NAME OF PROJECT: **Johnson Ranch**; Located at the northeast corner of the intersection of US 281 and FM 1863; Bulverde, Texas

TYPE OF PLAN: Request for Modification of an Approved Water Pollution Abatement Plan (WPAP); 30 Texas Administrative Code (TAC) Chapter 213 Edwards Aquifer

RE: Johnson Ranch WPAP Modification

This letter is submitted on behalf of the owner, DHJ Development, LLC, in support of the WPAP Modification for Johnson Ranch in response to comments issued September 24, 2012.

Official 7 1/2 Minute USGS Quadrangle Map of the Edwards Recharge Zone

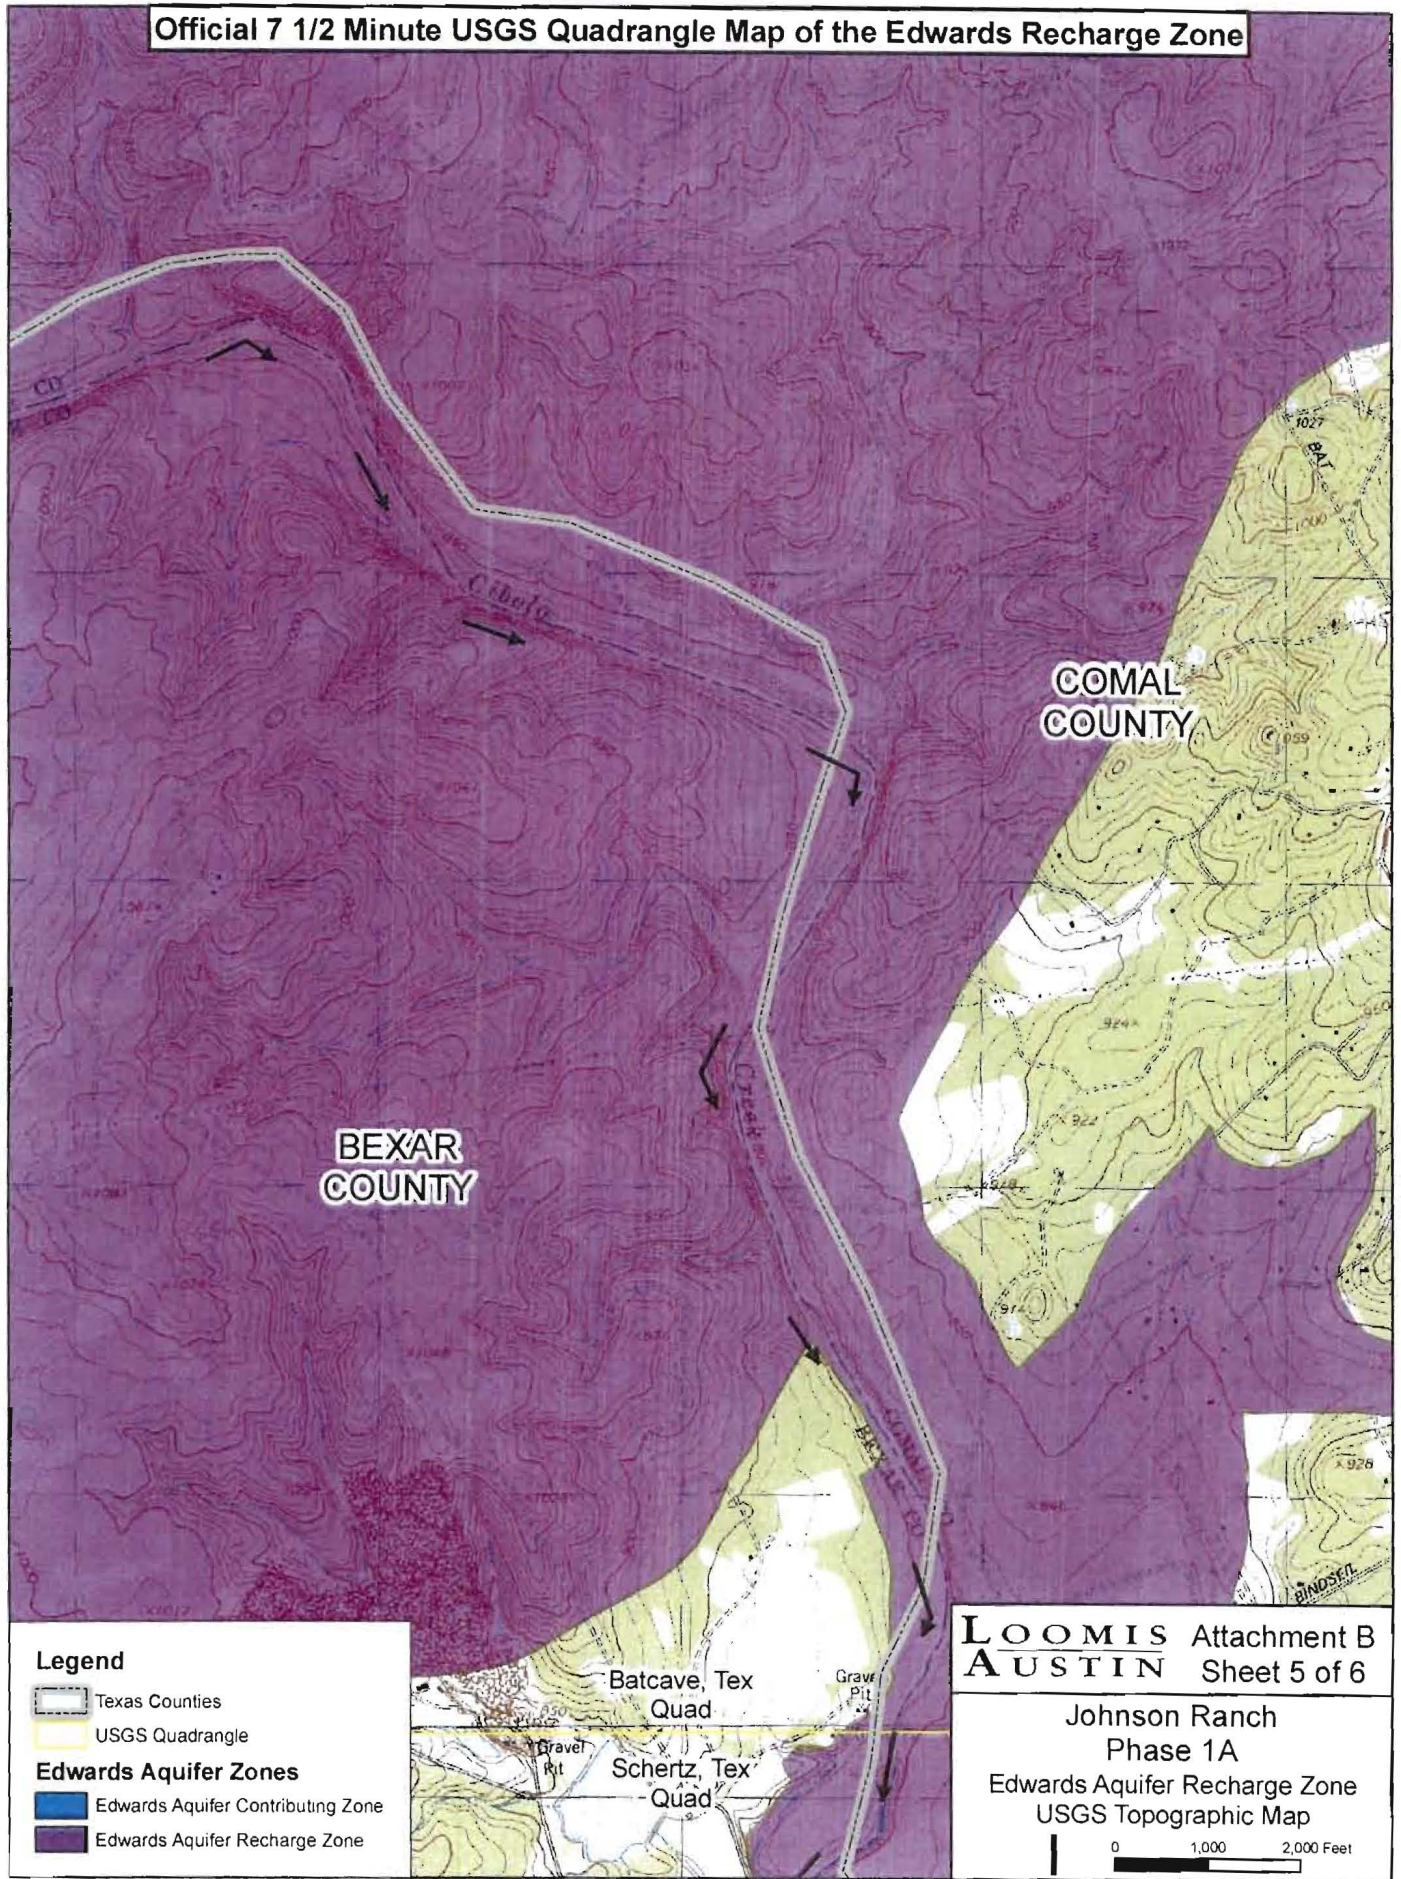
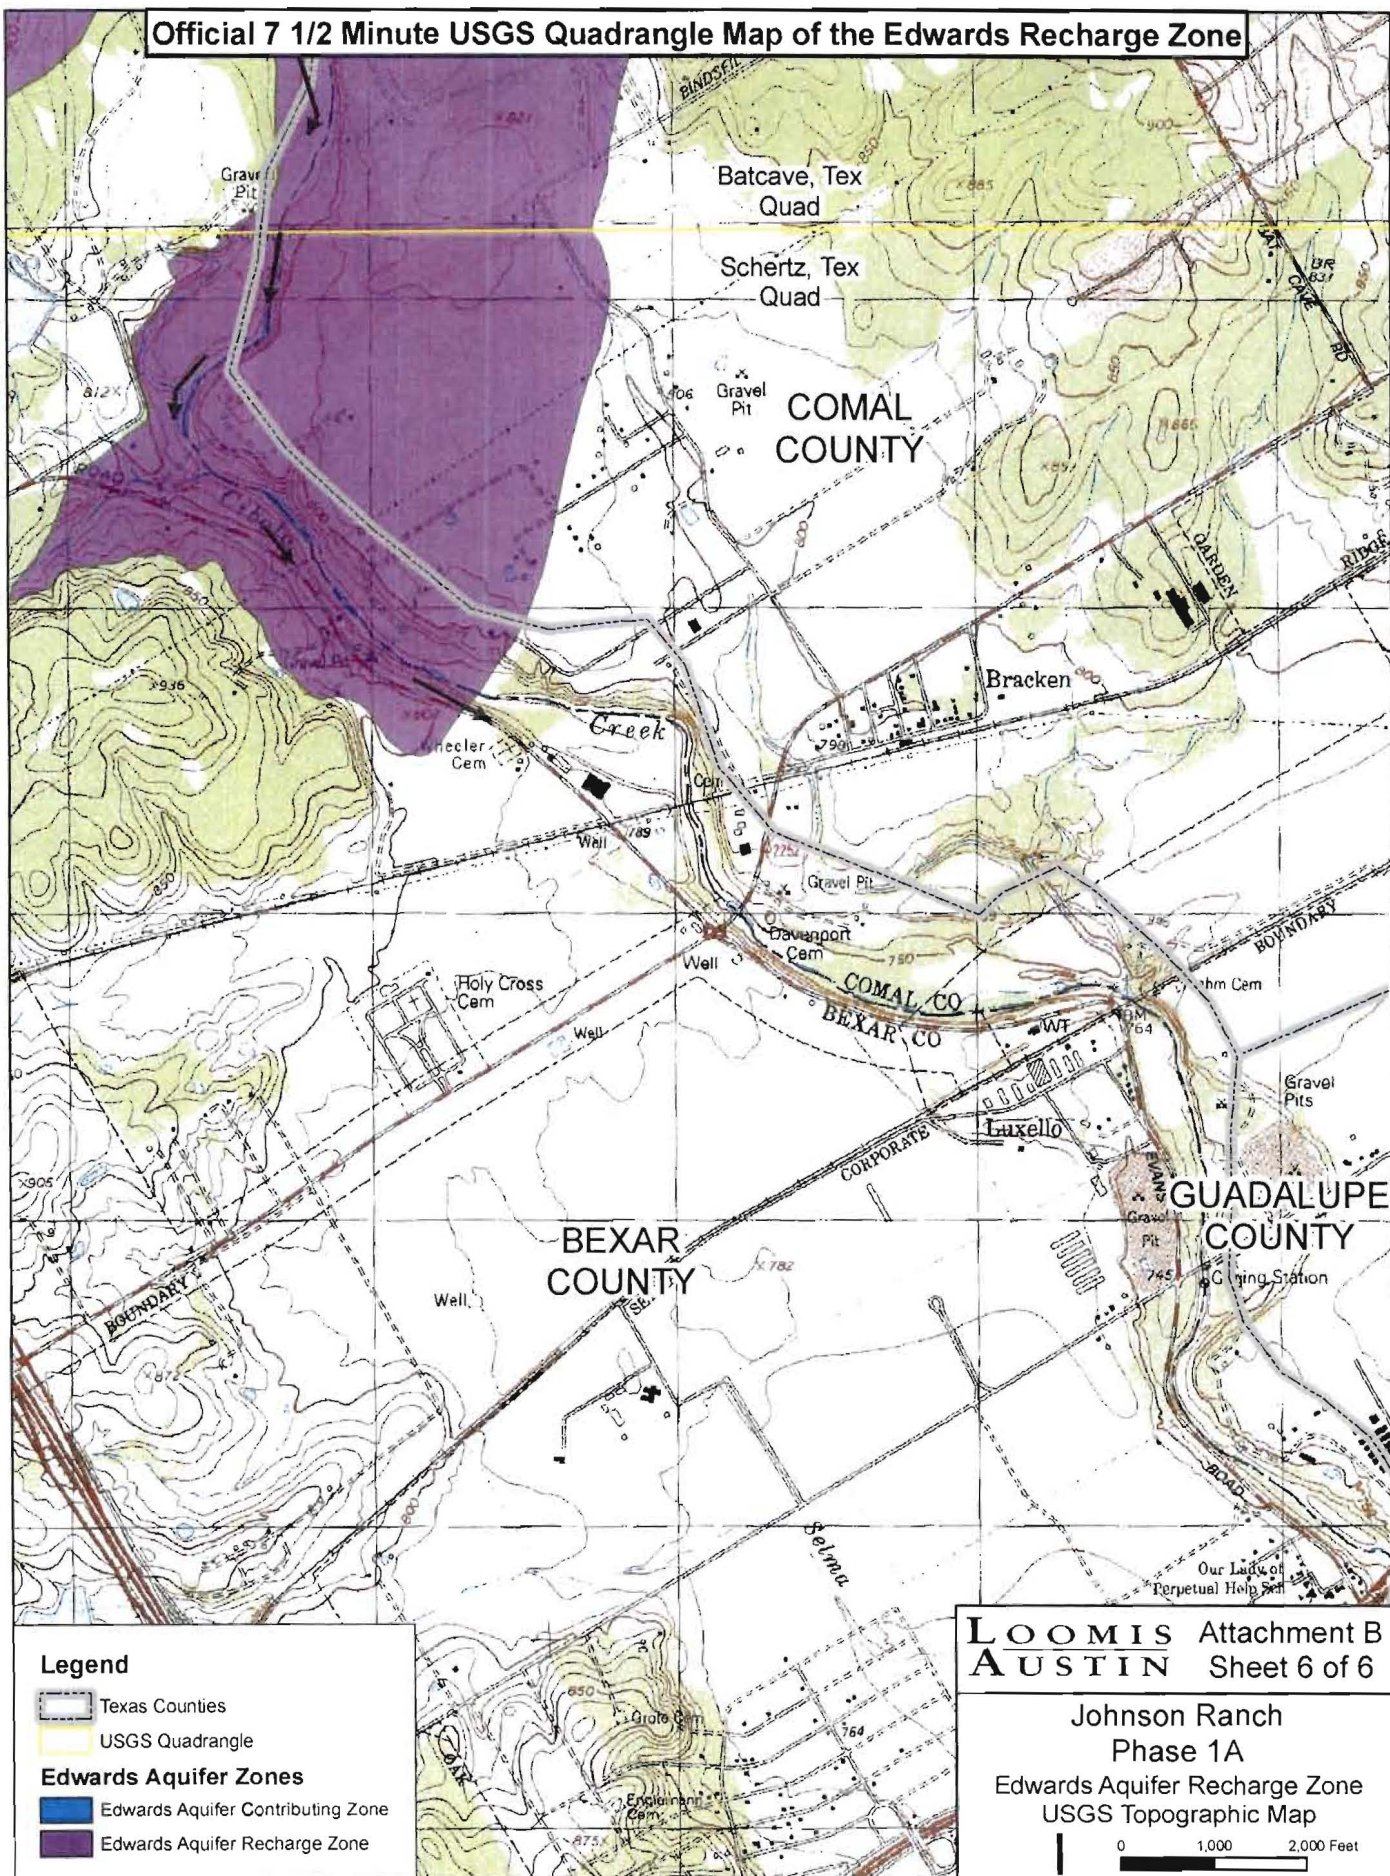
1. Please revise Project Description (Attachment C/General Information Form) to include reference to the actual modification including Unit 1 (Phases 1 and 2), Unit 2, Unit 3, Unit 4 and Unit 5 for clarification to reader. Revising the Attachment B (General Information Form) map to show the location of Units 1 through 5 would be most helpful to the reader.

Response: Attachments B and C of the General Information Form have been revised as requested and are attached.

The current WPAP modification will include Units 1, Phases 1 and 2, Unit 2, Unit 3, Unit 4, and Unit 5. These sections are labeled on Attachment B, USGS 7.5 Minute Quad of the Edwards Aquifer Recharge Zone.
